ERRATA
UNIT 1

ENVIRONMENTAL RADIOLOGICAL MONITORING PROGRAM SUMMARY
SAN ONOFRE NUCLEAR GENERATING STATION

Docket No. 50-206
San Diego County, California

Figure 8

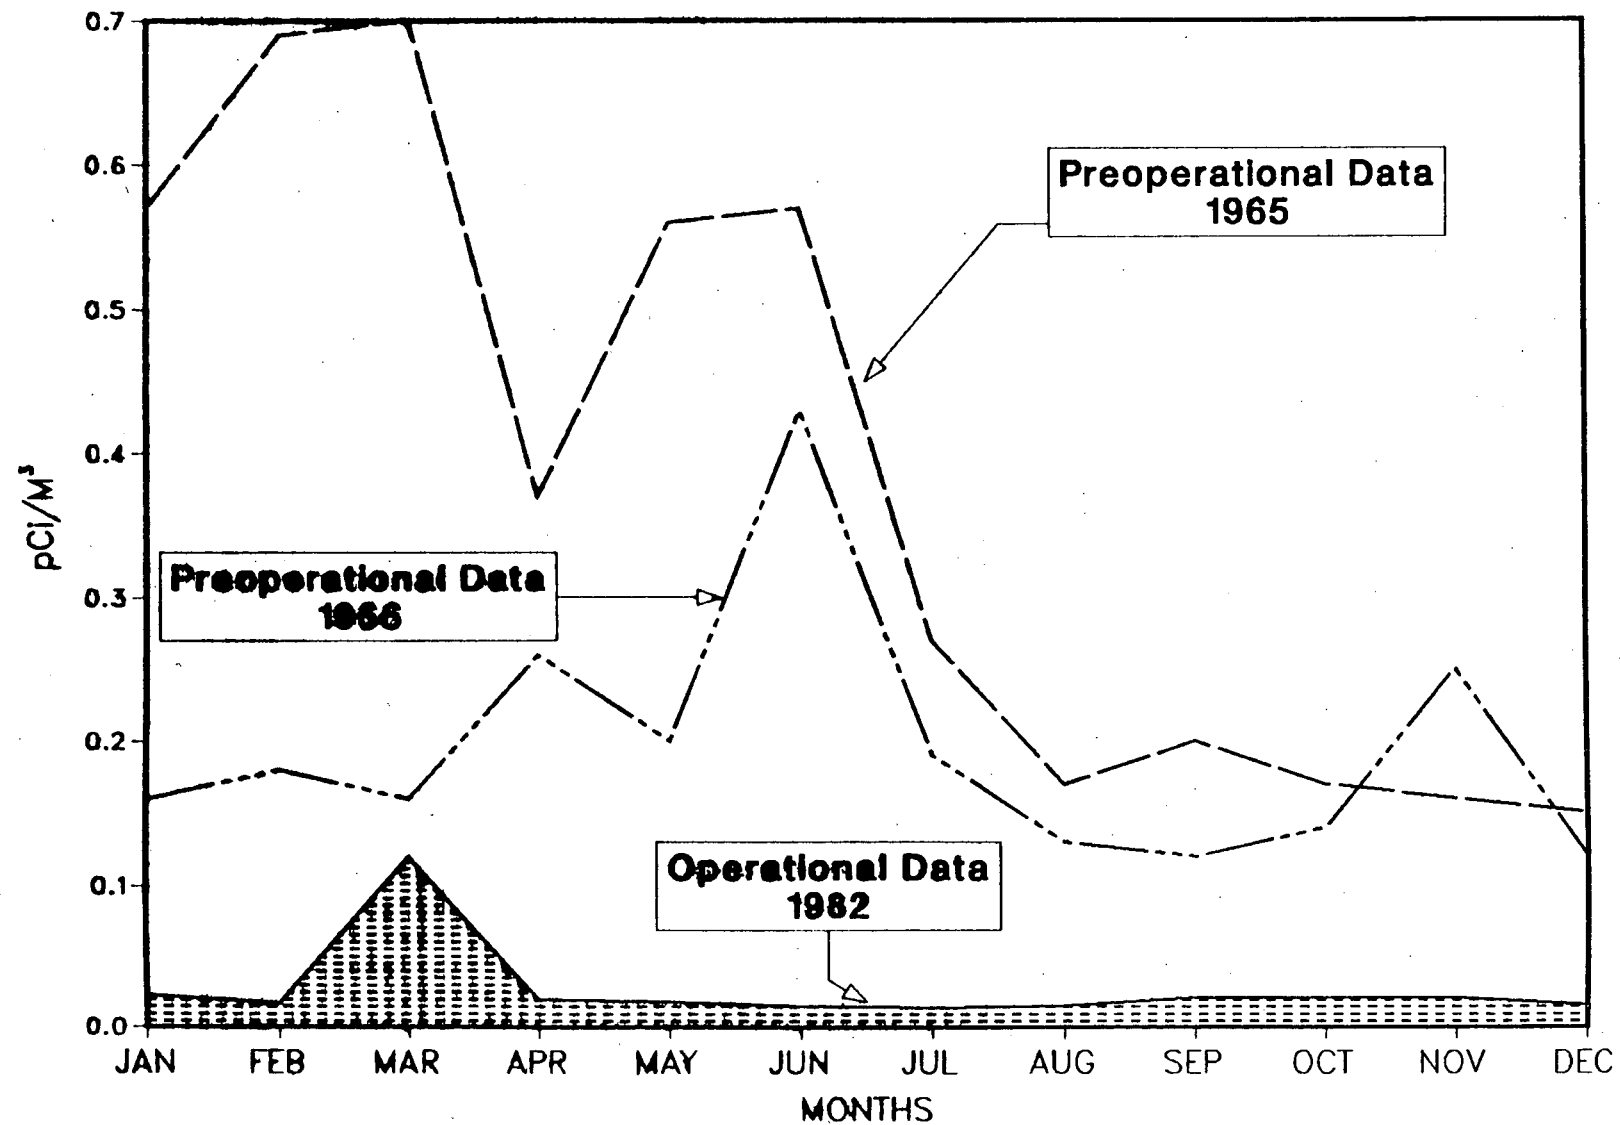
- ✓ 1. Line 5, Page E, of Appendix E, should be changed from Figure 14 to Figure 8.
- ✓ 2. Line 1, Part II-A.10 (Page 8) of the report, Results and Discussion, reads: "Rabbits were caught north and northeast of the site...." It should be corrected to read: "Rabbits were caught east of the site...."
- ✓ 3. Bottom of Page H-0, Appendix H should include the following:
